**AGENDA
PLANNING & ZONING COMMISSION
THURSDAY, November 14, 2019
7:00 P.M. TOWN HALL**

TITLE: Continued Public Hearing - Sopris Lofts – 1201 Colorado Avenue
Major Site Plan Review, Conditional Use Permit, Alternative Compliance
and an Amendment to Ordinance No. 18, Series of 2016

LU19-20-20 Stein 133 and Main - Major Site Plan Review - RESPONSE

TITLE: Sopris Lofts – 1201 Colorado Avenue
Major Site Plan Review and Conditional Use Permit

EXHIBIT 4

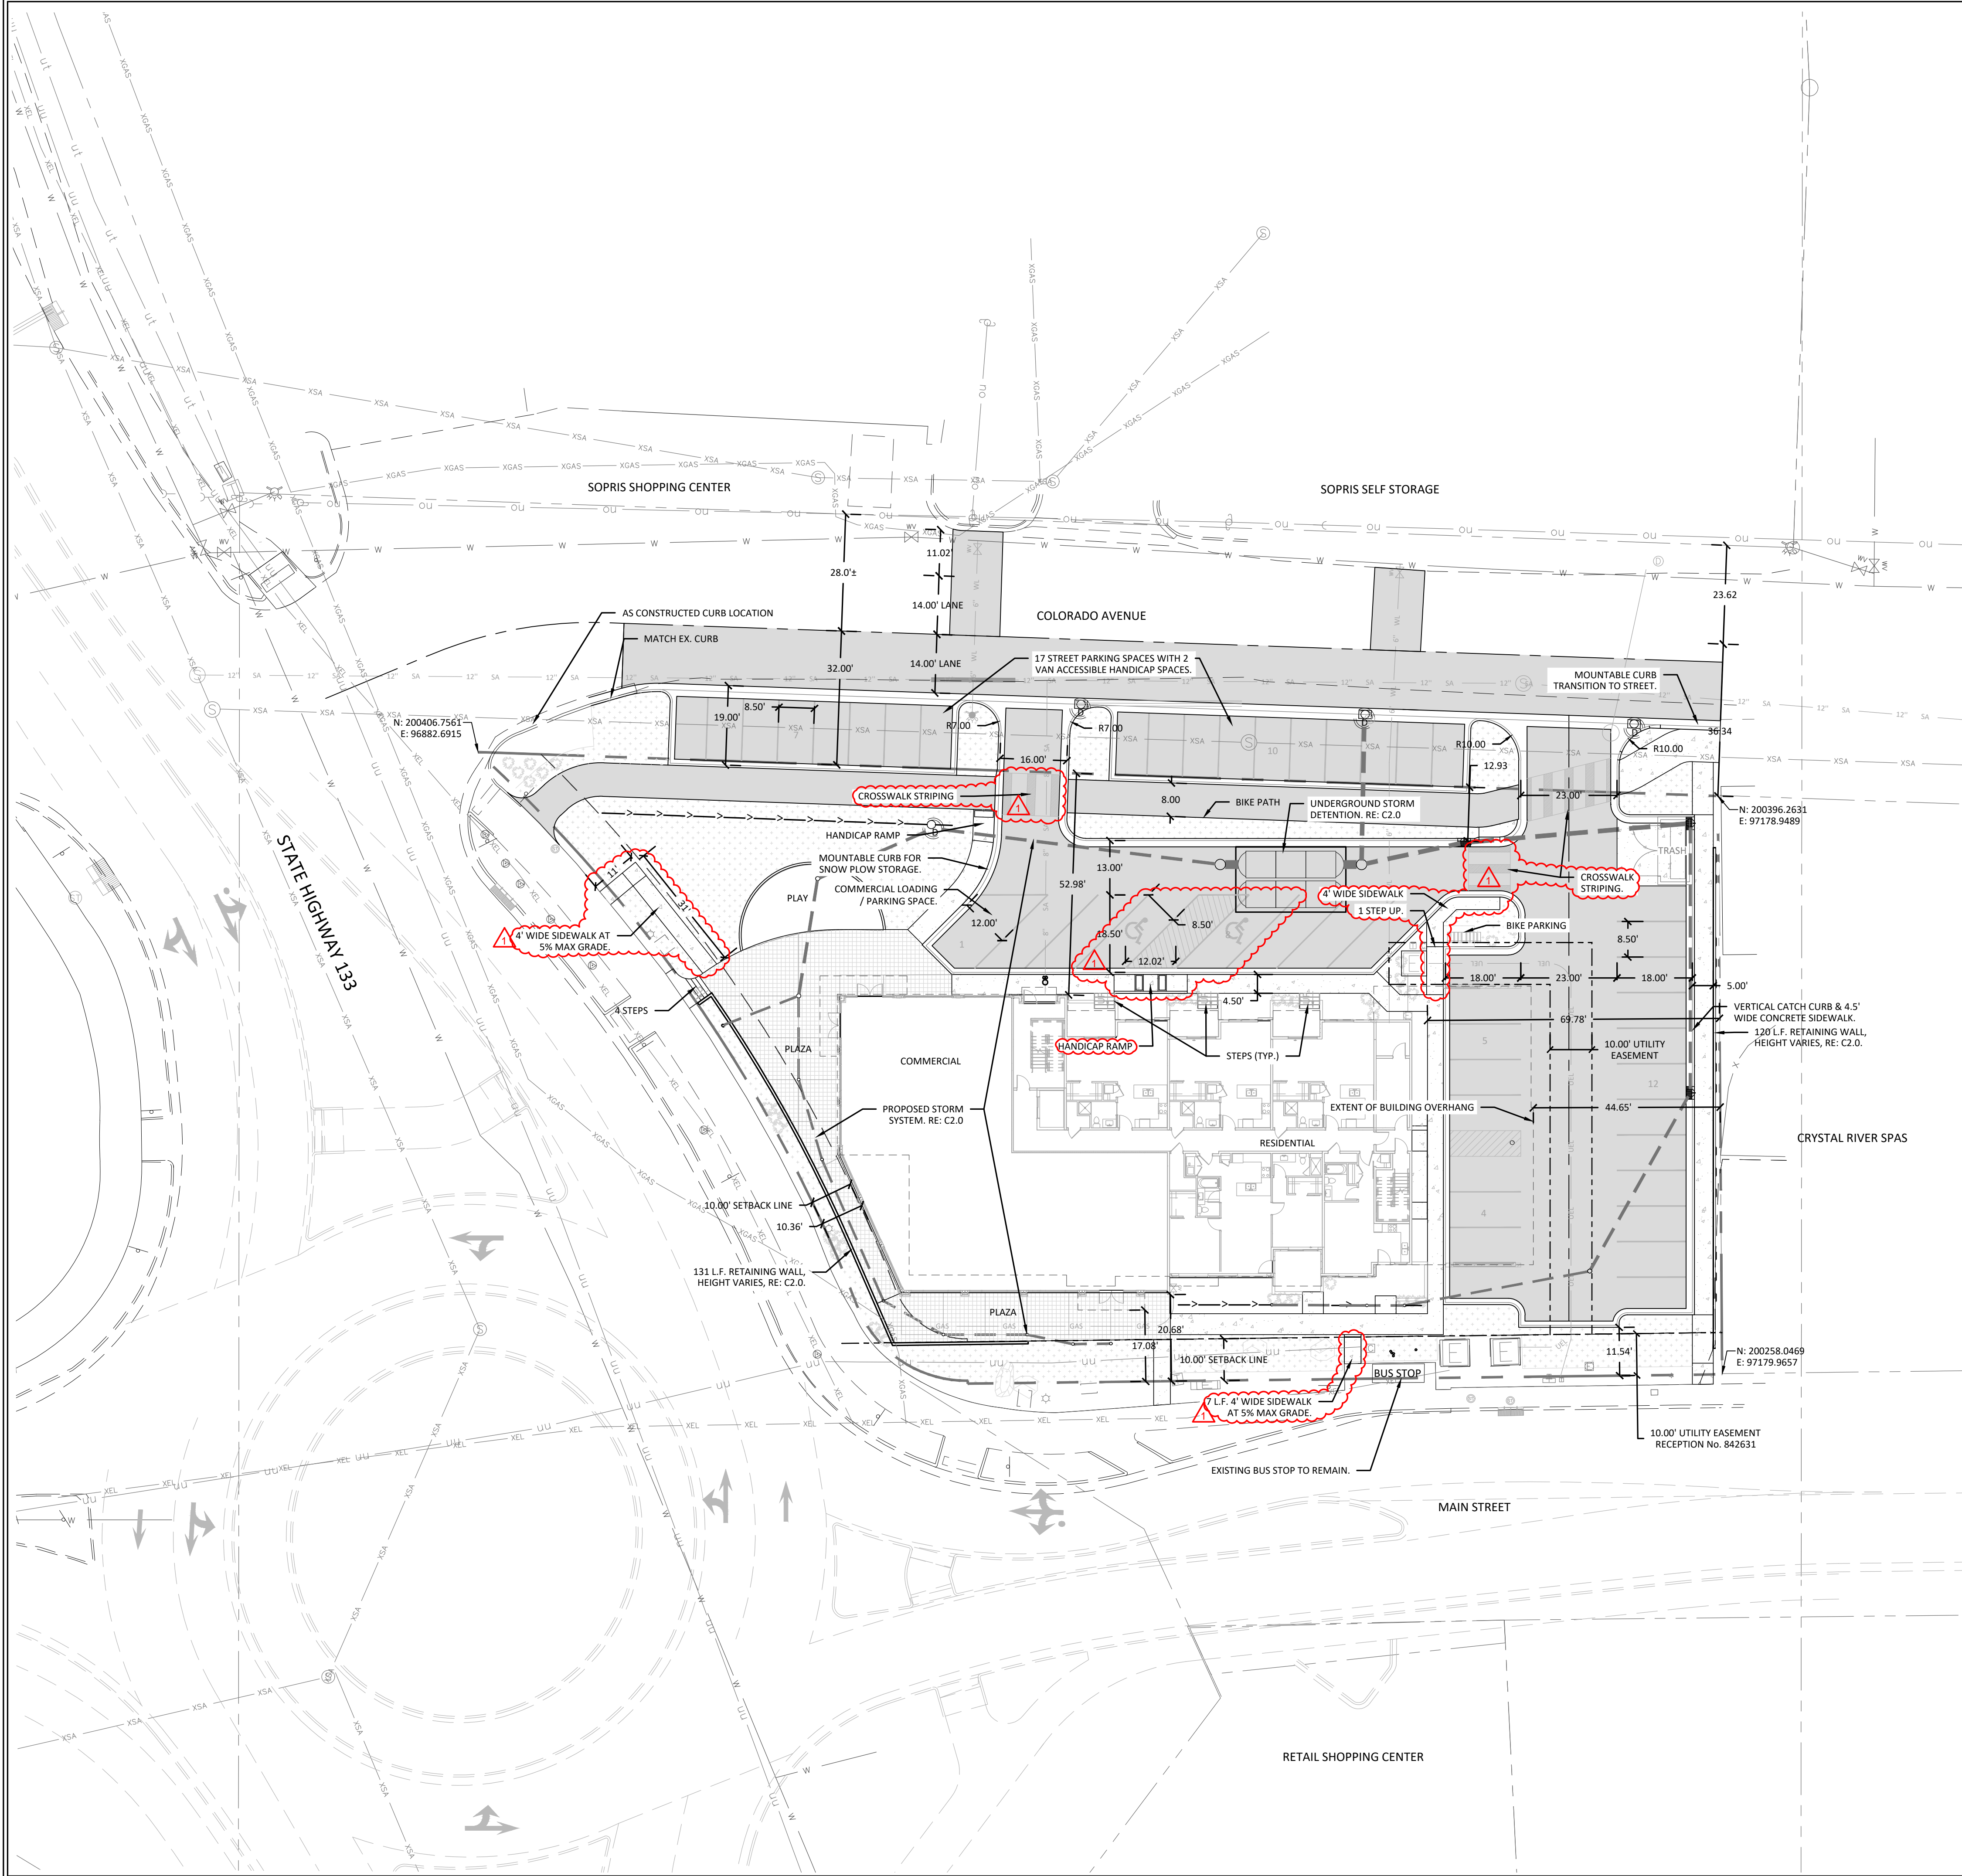
UDC Section 5.5.3.B.2. requires a pedestrian crosswalk from the northeast corner of the building to the easterly drive. This should be included on the site plan.

This had been addressed with a new connection on the South end of the site. Refer to Exhibit 4 for an updated site plan.

A new ADA compliant 1:20 (5%) walk has been added to the Northwest corner of the site to address this concern. Refer to Exhibit 4 for an updated site plan.

This has now been included in the site plan.
